Product Bulletin # PHDC-007

Pre-Charge Fuse Failure

Affected Units

Figure 1: PCH Relays

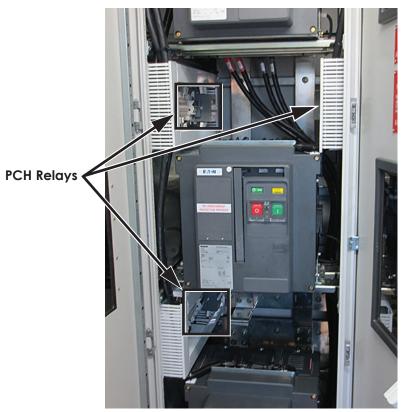
1. Remove the PCH relay contact from the PCC circuit as indicated below.

Figure 2: PCH 13 and PCH 14

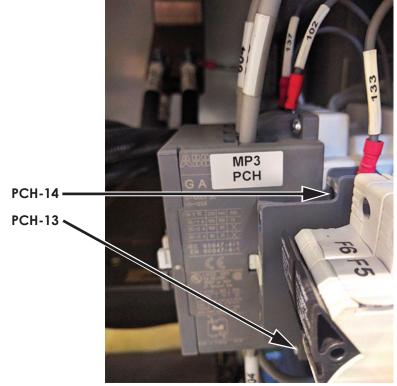
- a. Remove wire 1x063 between 1xTB02-05 and PCH-13. See Figure 2.
- b. Remove wire 1x013 between PCH-14 and 1xTB08-24.

- c. Add wire labeled 1x063 between 1xTB02-05 and 1xTB08-24.
- d. Replace labels on wire 1x013 with 1x063, between 1xTB08-24 and the VFD-DO3.

Figure 4: Replacing PCC Relay with Time Delay Relay

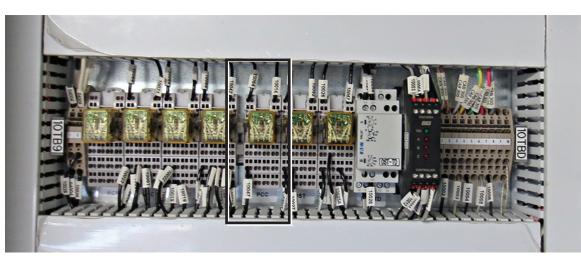
- 2. Remove wire 1x047 between PCC-5 and 1xTB08-13.
- 3. Remove wire 1x063 between 1xTB02-04 and 1xTB08-09.
- 4. Replace the PCC relay with a time delay relay Eaton TRL27 (Canrig P/N: E15361), see Figure 4 on page 5.

- a. Terminate wire 1x014 on PCC-A1 (Reroute/replace wire as necessary).
- b. Terminate wire 1x064 on PCC-A2 (Reroute/replace wire as necessary).
- c. Terminate wire 1x063 on PCC-15 (Reroute/replace wire as necessary).
- d. Set function dial to 'E' (On Delay). See Figure 5.
- e. Set time delay to 3 seconds.

Figure 6: PCH Relay

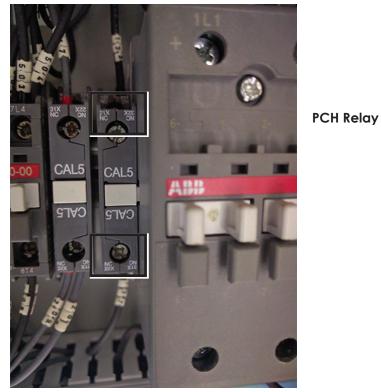
- 5. Add wire labeled 1x047 between PCC-18 and PCH-21.
- 6. Add wire labeled 1x053 between PCC-16 and 1xTB08-09.
- 7. Add wire labeled 1x054 between PCH-22 and 1xTB08-13.

Figure 9: PCC Relay Location on Nabors Rigs

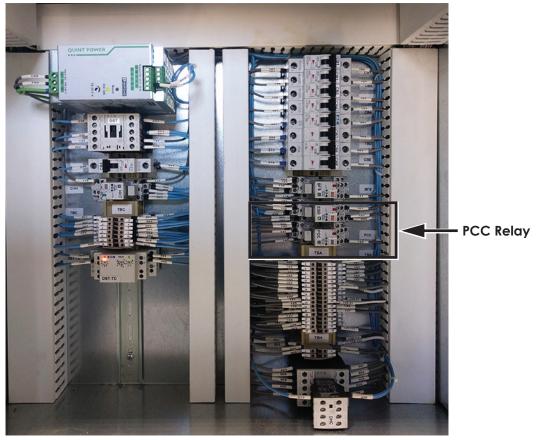
For steps below refer to Figure 9 and Figure 10 on page 9.

Figure 10: PCH Relay Location on Nabors Rigs

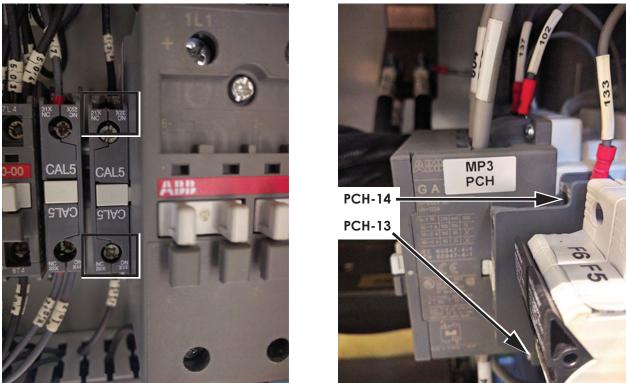
- 1. In the Power House, make the following wiring changes:
 - a. Remove wire 139 between PCH-14 and connection point TBA-27.
 - b. Remove wire 101 from PCH-13.
 - c. Add wire 101 between 120VAC supply terminals and TBA-27.
- 2. In the Driller's Cabin, make the following wiring changes:
 - a. Remove wire 139 between PCH-44 and VFD D03 connection point TB1-1.
 - b. Remove wire 101 from PCH-43.
 - c. Add wire 101 between 120VAC supply terminals and VFD D03 connection point TB1-1.
- 3. In both the Power House and Driller's Cabin, replace labels on wire 139 with 101, between TBA-27 and the VFD-D03.

Figure 11: Disconnect Switch Terminals X5

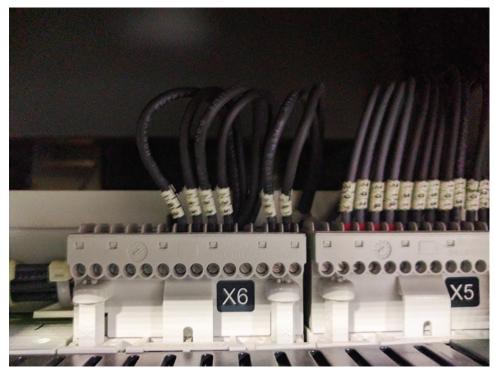
4. In both the Power House and Driller's Cabin, remove wire 101 between 120VAC supply terminal and the disconnect switch terminal X5-7. See Figure 11.

Figure 12: TRL27 Settings

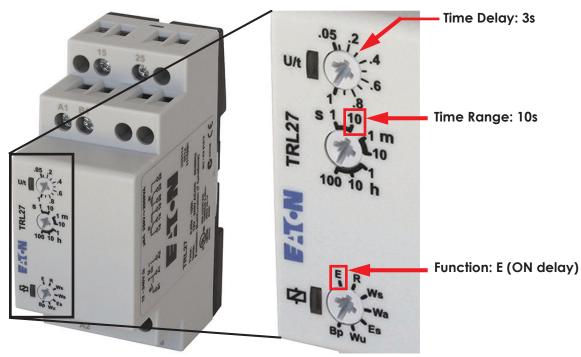
- 5. In both the Power House and Driller's Cabin, remove wire 131 between the disconnect switch terminal X5-8 and DST-43.
- 6. In the Power House, remove wire 145 between PCC-5 and TBA-29.
- 7. In the Driller's Cabin, remove wire 145 between PCC-5 and DS5 X6-7.
- In both the Power House and Driller's Cabin, replace the PCC relay with a time delay relay Eaton TRL27 (Canrig P/N: E15361) as follows:
 - a. Terminate wire 141 on PCC-A1 (Reroute/replace wire as necessary).
 - b. Terminate wire 102 on PCC-A2 (Reroute/replace wire as necessary).
 - c. Terminate wire 143 on PCC-15 (Reroute/replace wire as necessary).
 - d. Add wire labeled 131 between PCC-16 and DST-43.
 - e. Add wire labeled 145 between PCC-18 and PCH-21
 - f. Set function dial to 'E' (On Delay). See Figure 12 on page 12.
 - g. Set time delay to 3 seconds.
